## **ADDENDUM**

**PROJECT:** Forestside Estates  
Attmar & Palleschi Drive  
Brampton, Ontario

**PROJECT NO.:** 18-017

**ADDENDUM NO.** E-3

| 04  | SP | ISSUED FOR ADD E-3 | JAN. 19, 2020 |

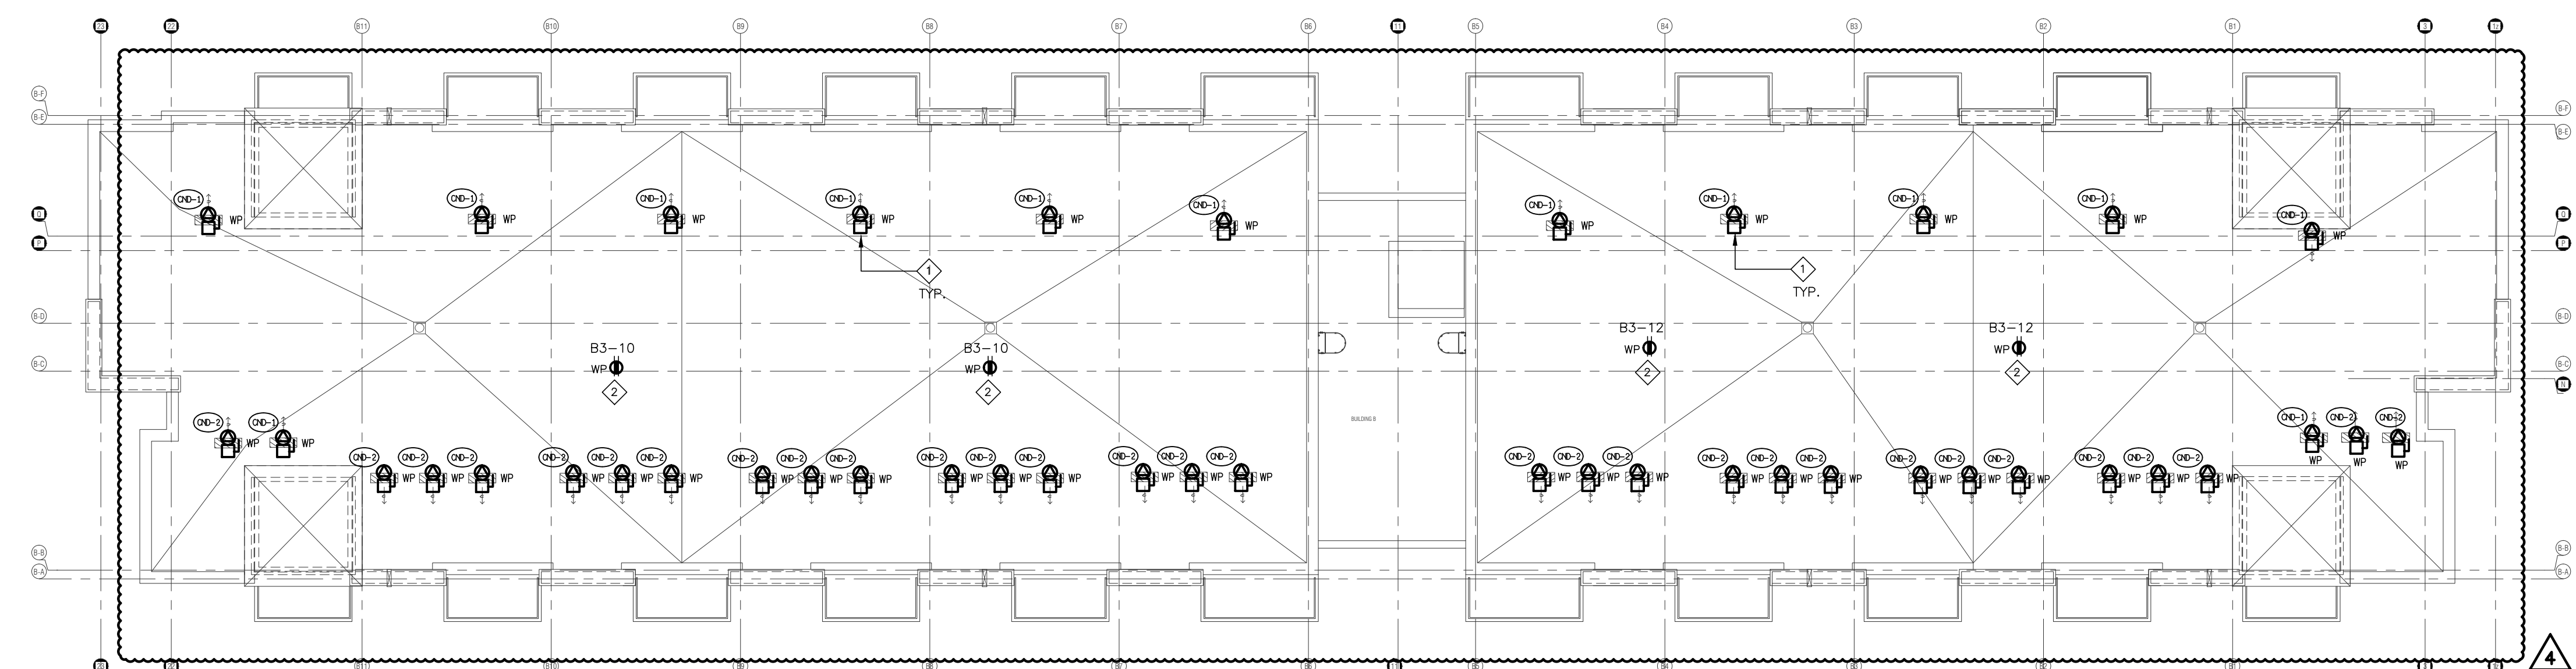
**2.0 Reference Drawings E-3 (Ground Floor - Electrical) Issued**  
**E-4 (2<sup>nd</sup> Floor- Electrical)**  
**E-5 (3<sup>rd</sup> Floor- Electrical)**  
**E-6 (4<sup>th</sup> Floor- Electrical)**  
**E-7 (Roof- Electrical)**

2.3 Relocate: Condensing units on the roof to suit mechanical drawings

19 SUITE LAYOUT TYPE 2A1 & 2A3  
GROUND FLOOR

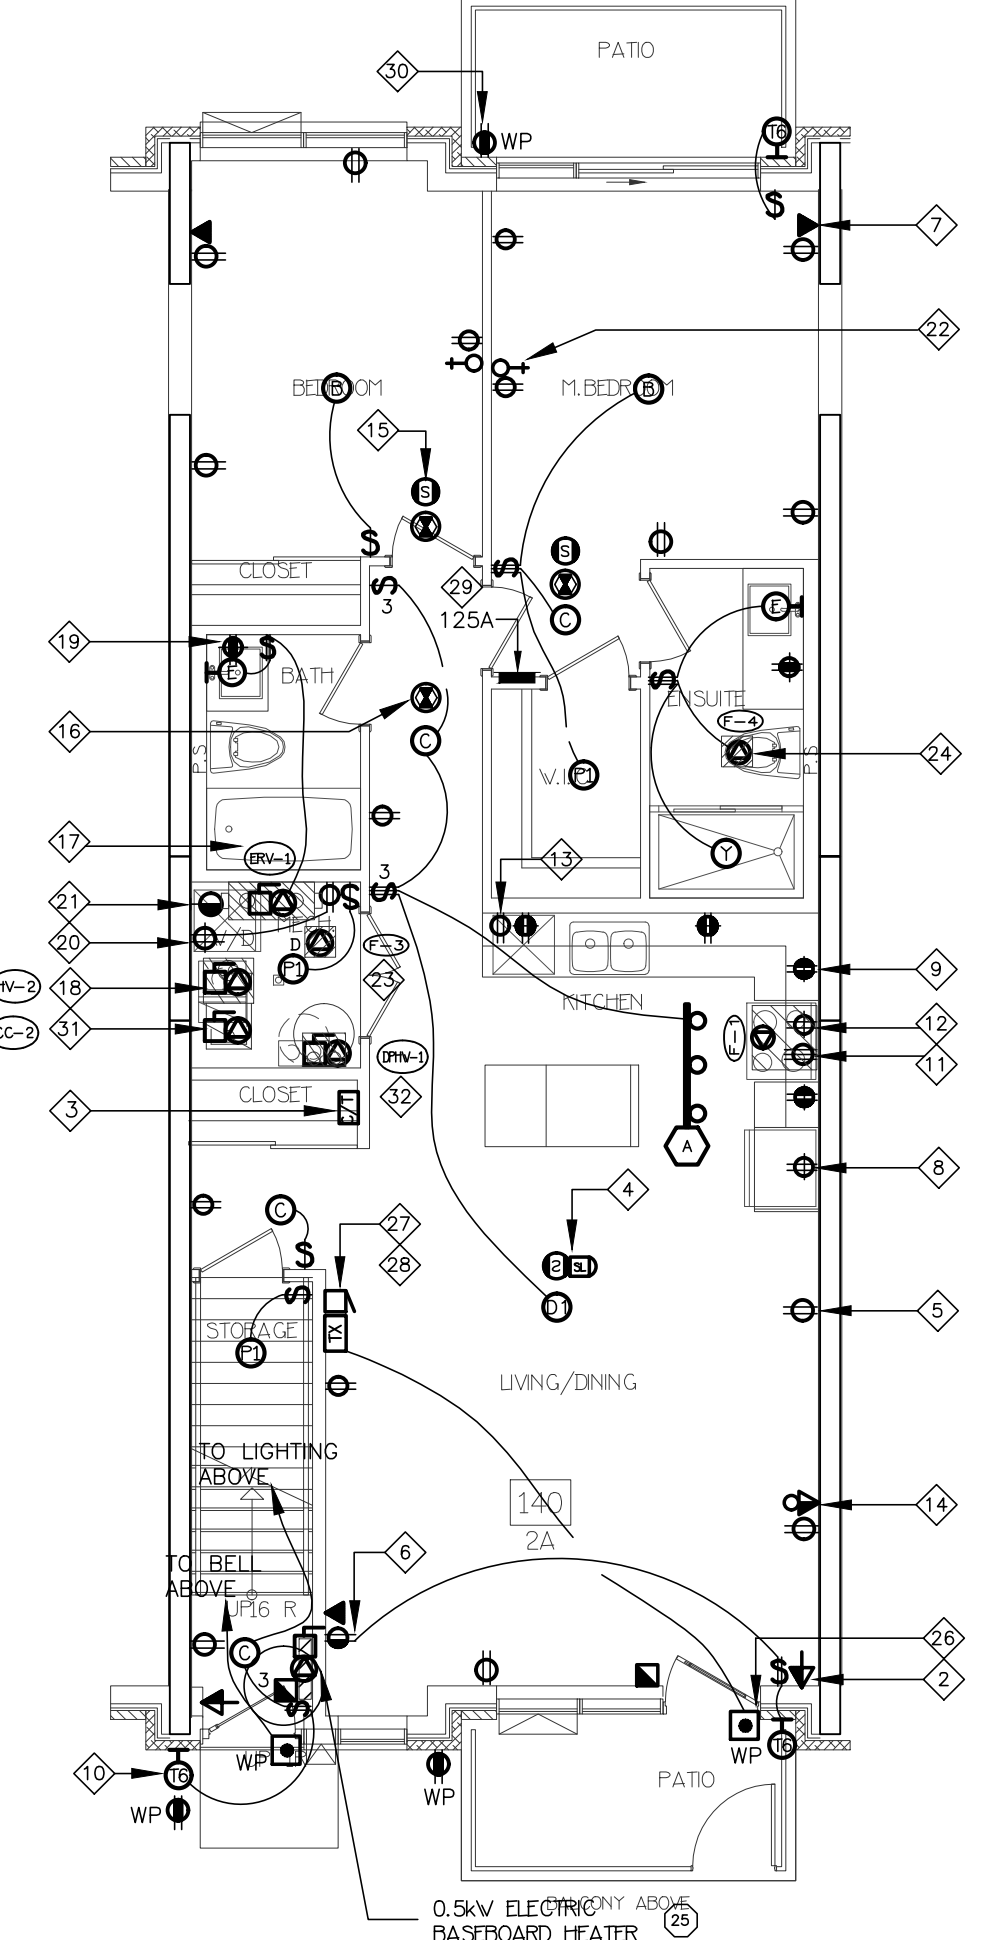
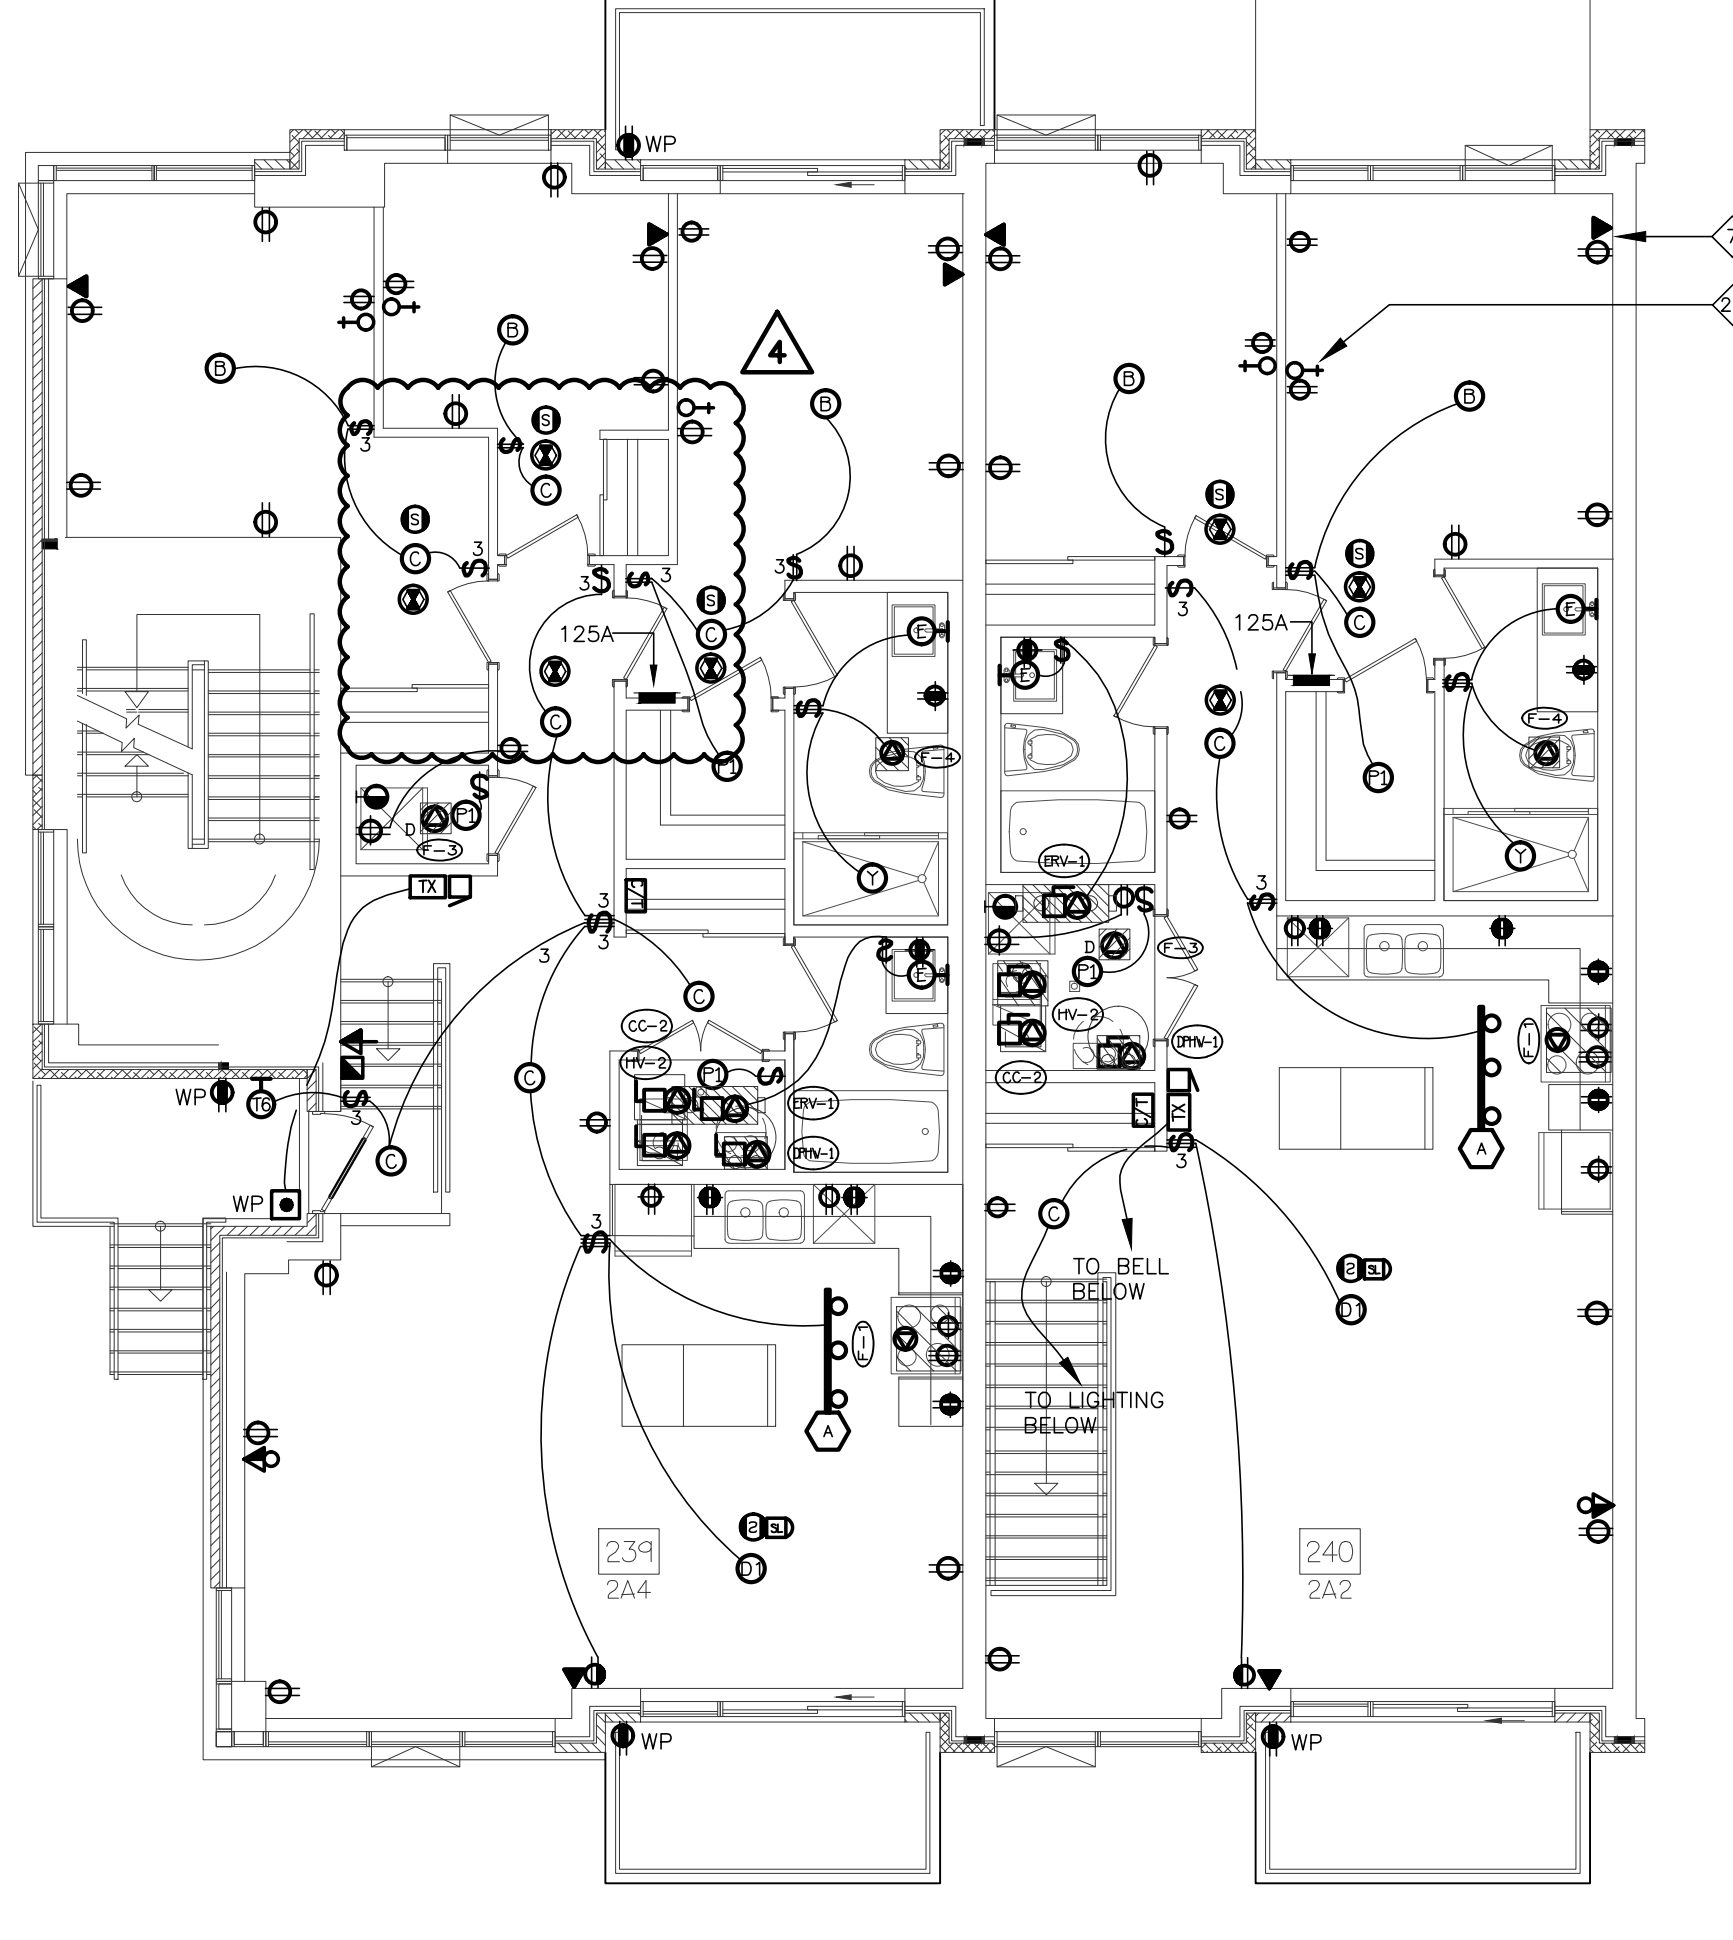
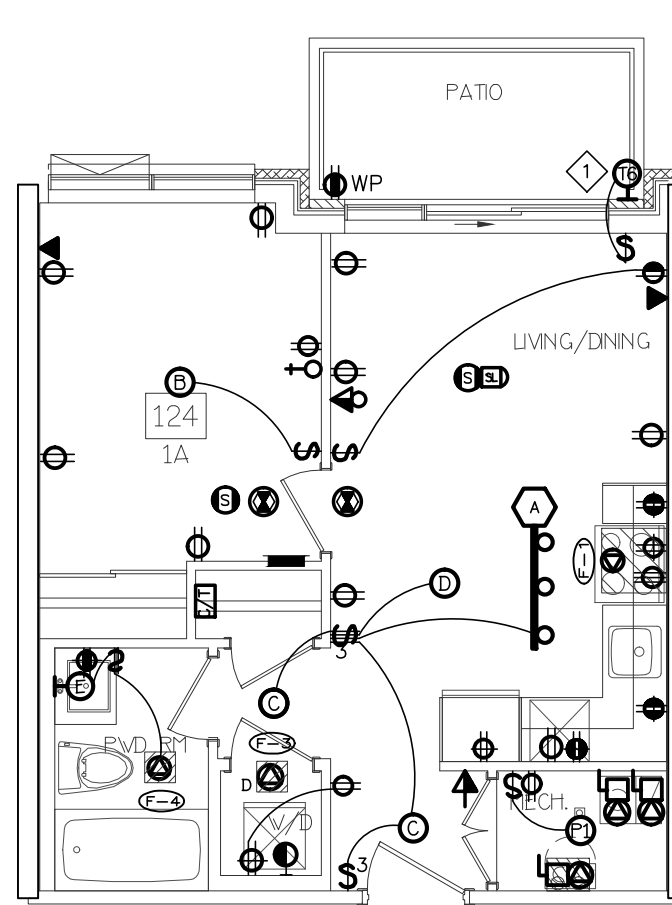
**3.0 Reference Drawings E-8 (Typical Suite Layout - Electrical) Issued**

3.1 Revise: Typical suite layout 2A3 name as 2A4 (second floor) as shown

3.2 Add: Typical suite layouts 2A1 & 2A3 as shown
